Submission for a Departure Standard

Project Name:	Andover – Western Avenue
Project Ref:	R.J509237.01
HCC DfS list Reference:	208
Client / Developer Details:	Test Valley Borough Council Beech Hurst, Weyhill Road, Andover SP10 3AJ
Consultant / Designer Details:	Engineering Services Hampshire County Council The Castle, Winchester SO23 8UJ
Date Submitted:	16 th April 2025, Revised 21 st May 2025

Details of Departure from Standard

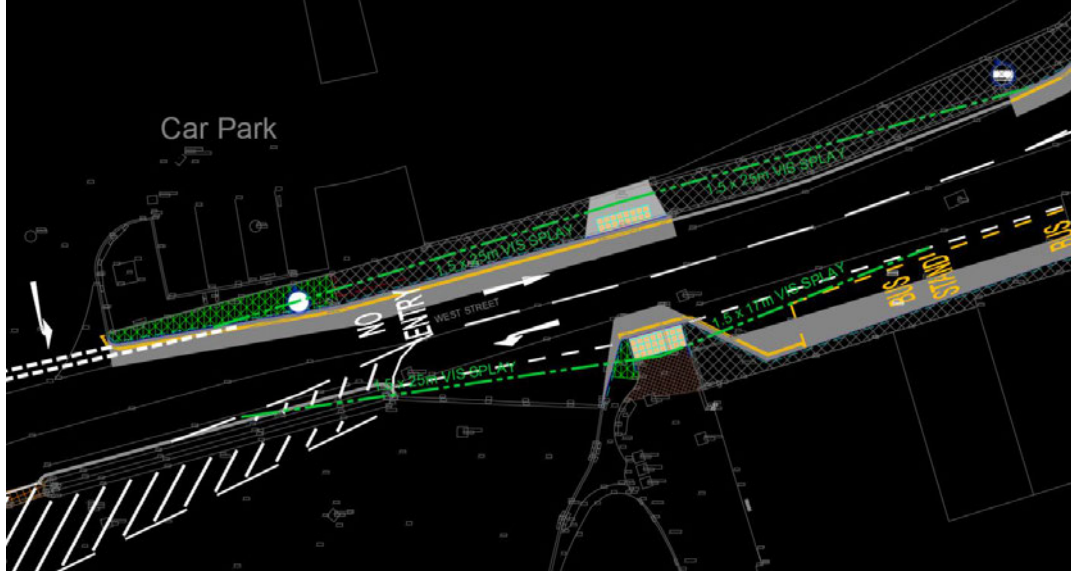
Minimum visibility "Y" distance of 25m for posted speed limit of 20mph not achievable to the East for pedestrians at uncontrolled crossing point due to proposed bus stands. Achievable visibility is 17m. The geometry of the road, with bus stands being on the outside of a curve allows for visibility to extend past the carriageway edge, so blind spot area created by buses is minimal.

The proposed highway changes will reduce traffic flows at the crossing location. 2024 baseline modelled (one-way only) AADT is 2494 vehicles (10.7% HGV) and projected 2040 modelled two-way AADT is 1951 (24.7% HGV).

Achievable visibility for pedestrians

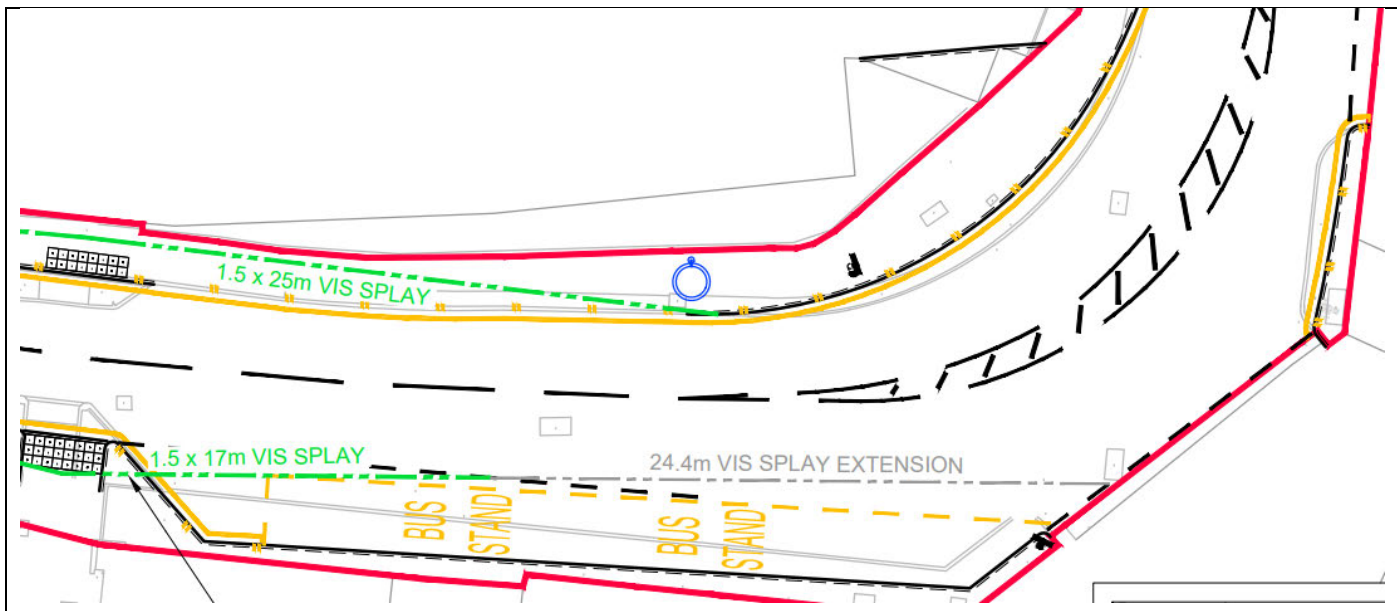
Approximate visibility from target Y distance. Encroachment into carriageway of left-hand crossing build out to be reduced

The blind area shown below is minimal, and it is unlikely that a vehicle would be hidden in this zone and traveling at speed towards the pedestrian crossing. This section of the road is intended for buses and lorries only on the approach to the crossing. There is good visibility of all approaching vehicles on carriageway prior to the hidden zone, therefore it is unlikely that pedestrians will not be aware of approaching vehicles.
